Access Compliance Report

Public Rights-of-Way

(Curb Ramps)

Intersection ID: 14249	Main Street: E_3RD_ST	Cross Street: QUEENS_RD	Location: NW
ADA ID: 655569C3623F	Ramp Type: Perpendicular Diagonal	Initial Pass/Fail: Fail	Overall Compliance: No
			Severity Score: 21.25

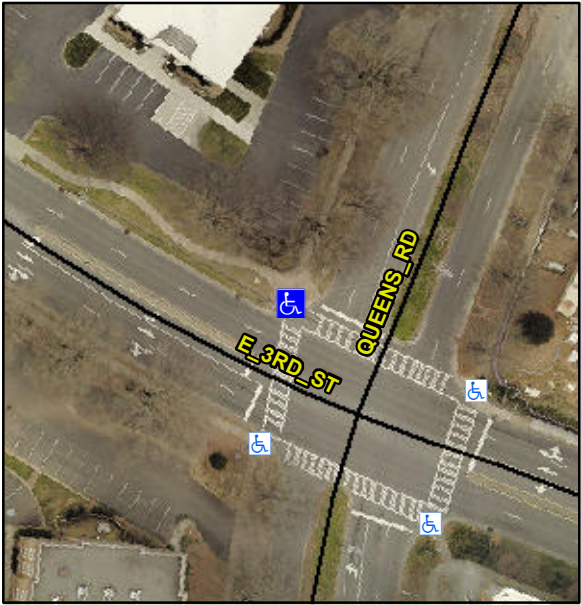
Codes/Mitigation Info/Possible Solution			Field Measurements/Component Compliance		
	Possible Solutions:		Compliance	Description	Data
	Remove & Replace Curb Ramp With Two New Directional Ramps or Equivalent.		No	Ramp Length (in)	48.0
			No	Ramp Width (in)	39.0
			N/A	Flare Type LT	N/A
			N/A	Flare Slope LT (%)	N/A
			N/A	Flare Traversable LT?	N/A
			N/A	Landing Length (in)	N/A
			N/A	Landing Width (in)	N/A
			N/A	Landing Slope (%)	N/A
			N/A	Landing X Slope (%)	N/A
<p>Surveyor Notes:</p> <p>N/A</p> <p>PROW/ADA:</p> <p>Not Found, R304.5.1, R304.2.2</p>			N/A	Flare Type RT	N/A
			N/A	Flare Slope RT (%)	N/A
			N/A	Flare Traversable RT?	N/A
			N/A	DWS Provided?	N/A
			N/A	DWS Contrast?	N/A
			N/A	DWS Length (in)	N/A
			N/A	DWS Full Width?	N/A
			N/A	DWS Offset (in)	N/A
			N/A	Shared Landing?	N/A
			N/A	Gutter Ponding?	N/A
			N/A	Gutter Lip Ht (in)	N/A
			N/A	Painted X Walk1?	Yes
				X Walk 1 Direction	To SW
			N/A	X Walk 1 Width (in)	106.0

X Walk 1 Slope (%)	2.7
				X Walk 1 X Slope (%)	3.5
			N/A	Ramp inside XWalk1?	Yes
				Road Slope (%)	0.8
				Road X Slope (%)	3.8
			N/A	Any Obstructions?	N/A
				Obstruction Type	
Total Cost:		\$ 3200.00			
			N/A		
			Yes	Surface Condition? (G/P)	Good
